Service Bulletin

Subject: SES Lamp On With DTC P151E

Models: 2015 Chevrolet Colorado
2015 GMC Canyon
Equipped with 3.6L Engine (RPO LFX)
Built prior to 1/15/2015

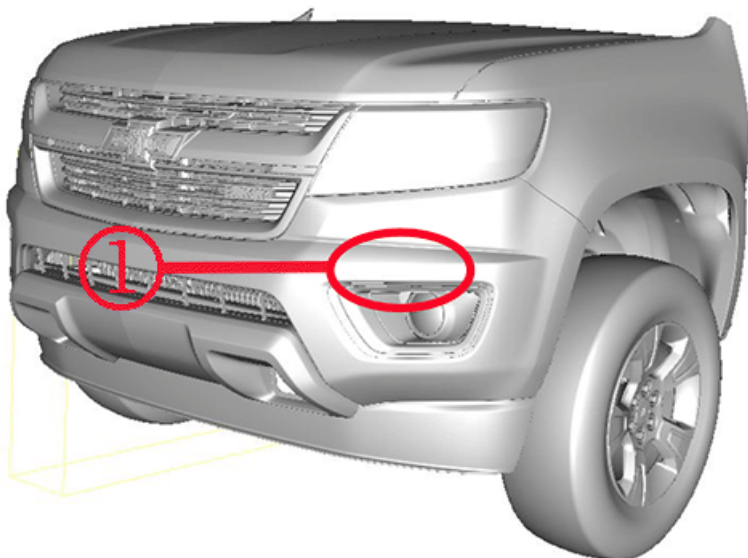
This jumper will be installed between the connector halves of X105 which is attached to the tie bar behind the left side of the fascia. The picture (1) below indicates its position but the fascia does not need to be removed for this procedure.

Separate the connector halves, install jumper harness PN 23390136 between them, and ensure they snap together.
